Upper Occoquan Service Authority

For UOSA RFP 24-15 Furnish and Deliver Gas Booster

SUBJECT: Addendum # 2

RFP 24-15 Addendum #2 Attachment A – Questions and Answers

TITLE: DIMENSIONS OF A 24 INCH HERMETIC

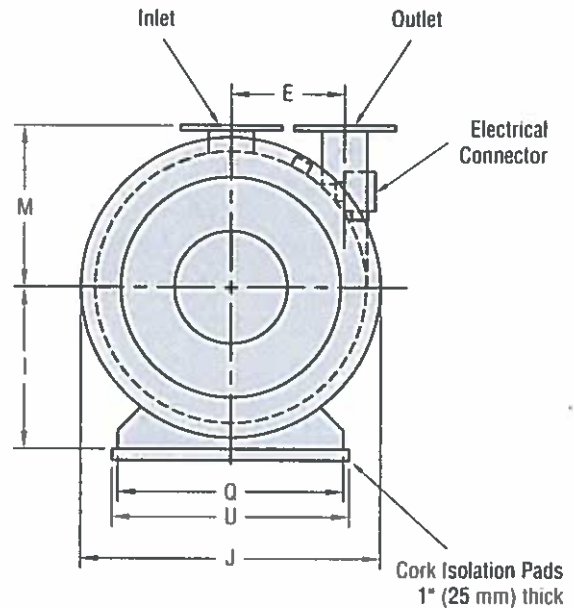
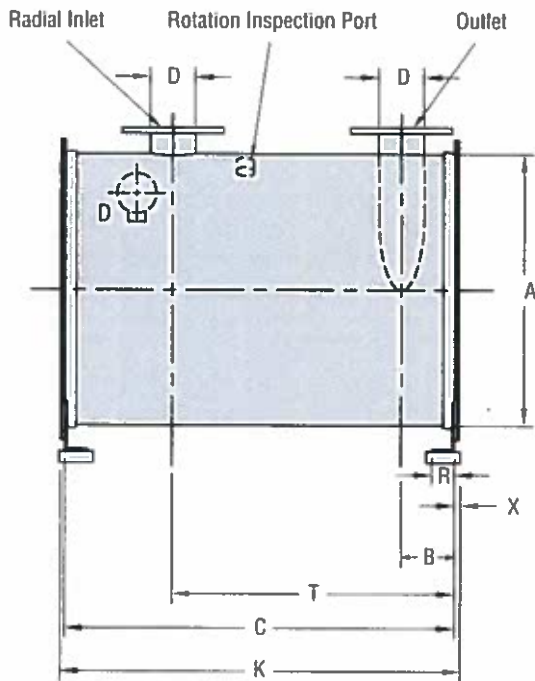
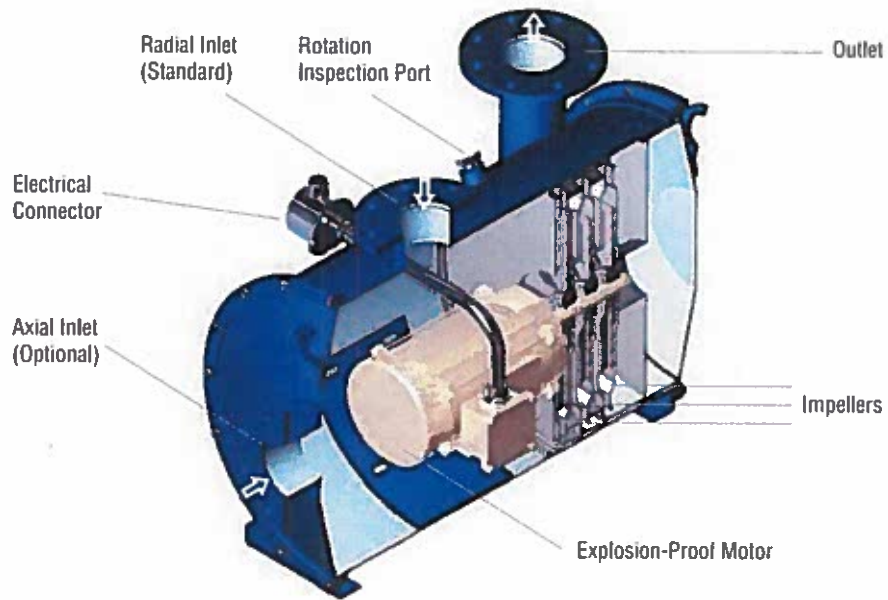
3. Q: Can you provide details for existing blower as I did not find anything in the addendum.

A: Please see attached drawings.
